Service description

Product: SP400	Service description no: 3125-S010	Ver: 1
-------------------	---	-----------

The double gearbox replacement.

Figure 1

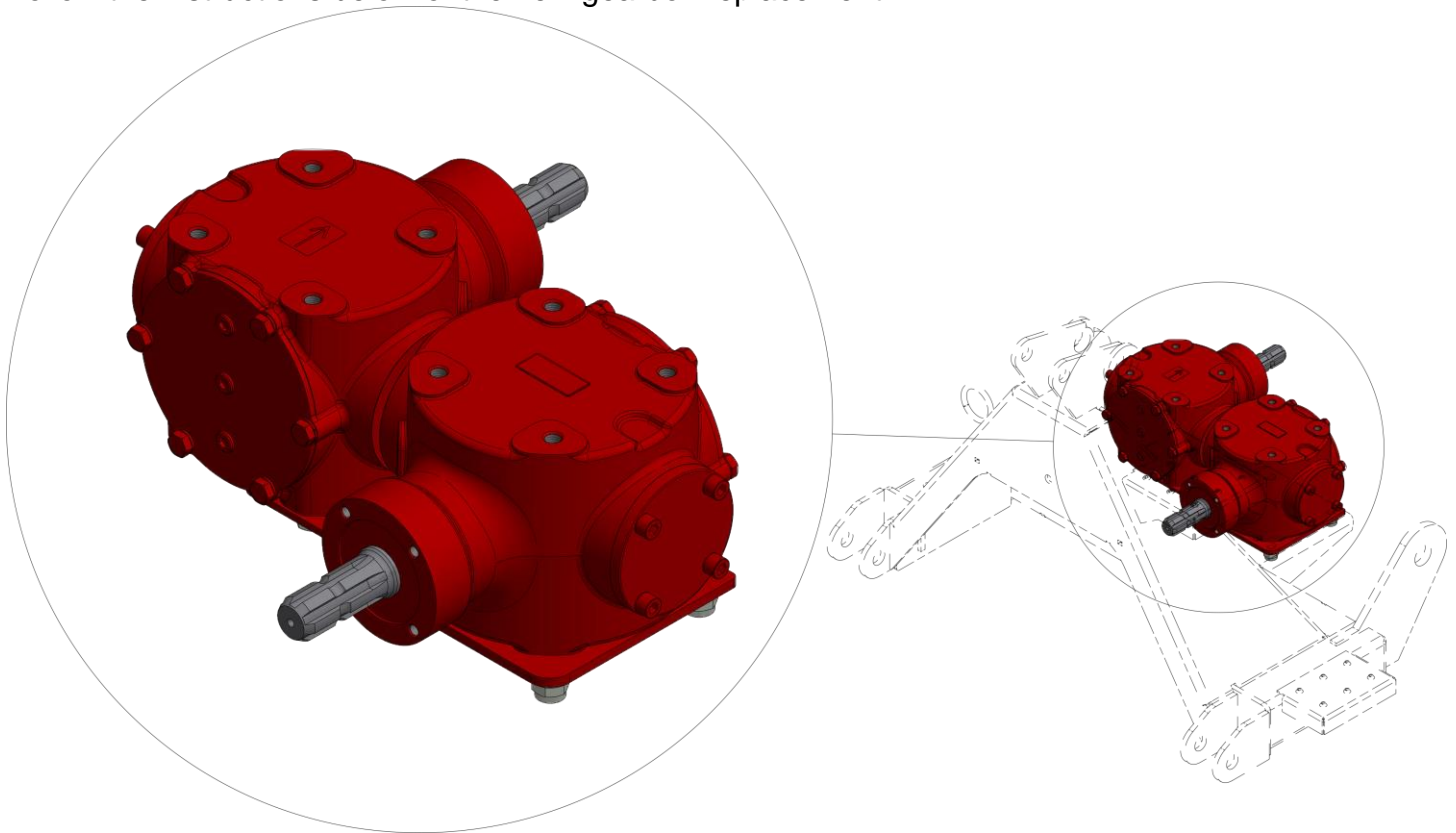
The hole pattern in the new gearbox does not match the hole pattern on the tractor attachment.

Follow the instructions below of the new gearbox replacement.
